State of New Mexico
Energy, Minerals and Natural Resources

7. Lease Name or Unit Agreement Name
Randleman

8. Well Number #1R

SUNDRY NOTICES AND REPORTS ON WELLS

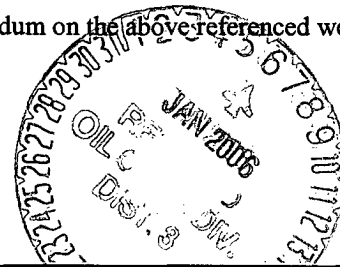
It is intended to change the operations plan as shown on the attached wellbore diagram and memorandum on the above referenced well. Verbal approval was obtained by Steve Hayden, NMOCD, on 1/5/05 at 2:20 pm for this change.

wellbore design chg to add

extra csg string into plans

Plan to drill 17 1/2" hole for surface + run 13 3/8" csg

then 12 1/4" hole + run 9 5/8" csg to 2753'

then 8 3/4" hole to 6274' (100' below Gallops) + run 7" csg

take surveys all along - assuming

hit crack - leave open hole w/ 4 1/2" liner
